Product Change Notification / SYST-31HPWF472

ERRATA - dsPIC33CH128MP508 Family Silicon Errata and Datasheet Clarification

dsPIC33CH128MP508 Family Silicon Errata and Data Sheet Clarification

FIGURE 1: I/O RAMP

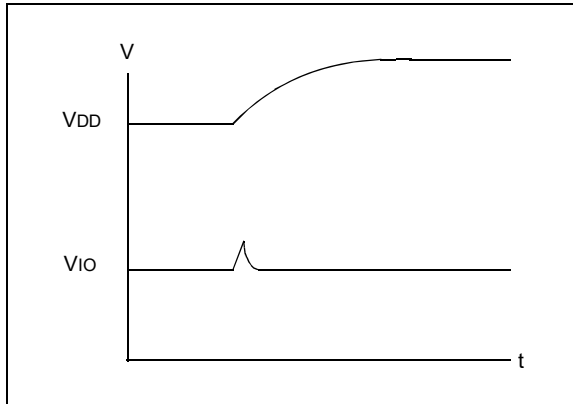
26. Module: I/O

During a fast device power-up, when the VDD ramp is less than 4 mS, the I/O pins may drive up to 100 μ A current for a duration of up to 10 μ S (Figure 1).

Work around

1. Slow down the VDD ramp time (greater than 4 mS for VDD to ramp 0V to 3.3V).
2. Ensure the circuitry that is connected to the pins can endure this pulse.

Example applications affected may include complementary power switches, where a transient current shoot-through might occur.

High-voltage applications with complementary switches should power the high-voltage 200 μ Sec later than powering the dsPIC[®] device to avoid the current shoot-through. This behavior is specific to each device and not affected by aging.

FIGURE 2-2: SUGGESTED PLACEMENT OF THE OSCILLATOR CIRCUIT

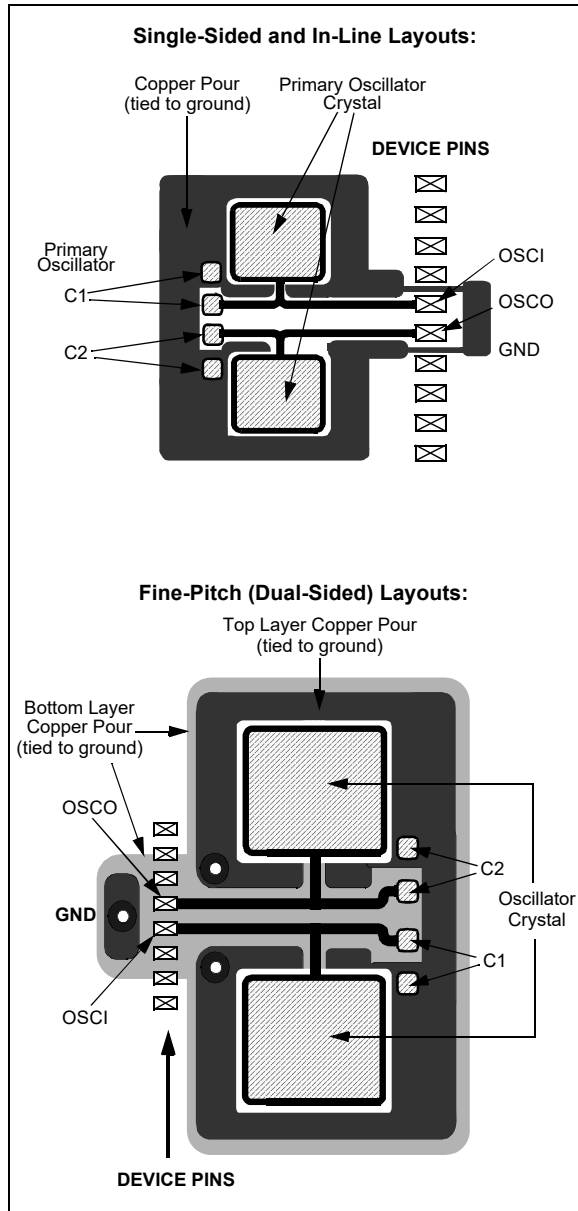
Additional information is added to [Section 2.5 “External Oscillator Pins”](#) and [Section 2.6 “External Oscillator Layout Guidance”](#) is added.

2.6 External Oscillator Layout Guidance

Use best practices during PCB layout to ensure robust start-up and operation. The oscillator circuit should be placed on the same side of the board as the device. Also, place the oscillator circuit close to the respective oscillator pins, not exceeding one-half inch (12 mm) distance between them. The load capacitors should be placed next to the oscillator itself, on the same side of the board. Use a grounded copper pour around the oscillator circuit to isolate it from surrounding circuits. The grounded copper pour should be routed directly to the MCU ground. Do not run any signal traces or power traces inside the ground pour. If using a two-sided board, avoid any traces on the other side of the board where the crystal is placed. Suggested layouts are shown in [Figure 2-2](#). With fine-pitch packages, it is not always possible to completely surround the pins and components. A suitable solution is to tie the broken guard sections to a mirrored ground layer. In all cases, the guard trace(s) must be returned to ground.

FIGURE: ADC ANALOG INPUT MODEL

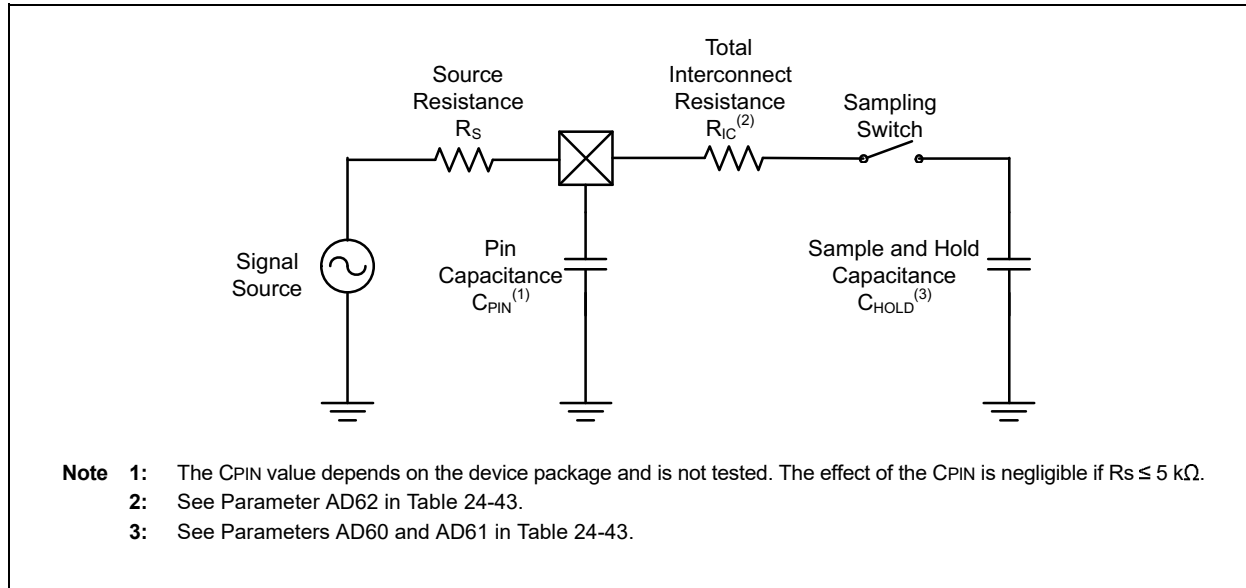
The following [Sampling Time Requirements](#) section has been added to both **Section 3.9** “High-Speed, 12-Bit Analog-to-Digital Converter (Main Core ADC)” and **Section 4.7** “High-Speed, 12-Bit Analog-to-Digital Converter (Secondary Core ADC)”.

The analog input model of the ADC is shown in the figure below.

The total acquisition time for the Analog-to-Digital conversion is a function of the Holding Capacitor (C_{HOLD}) charge time. For the ADC module to meet its specified accuracy, the Holding Capacitor (C_{HOLD}) must be allowed to fully charge to the voltage level on the analog input pin. The Signal Source Impedance (R_S)

and the Interconnect Impedance (R_{IC}) combine to affect the time required to charge the C_{HOLD} . The total resistance ($R_S + R_{IC}$) must therefore, be small enough to fully charge the Holding Capacitor within the selected sample time.
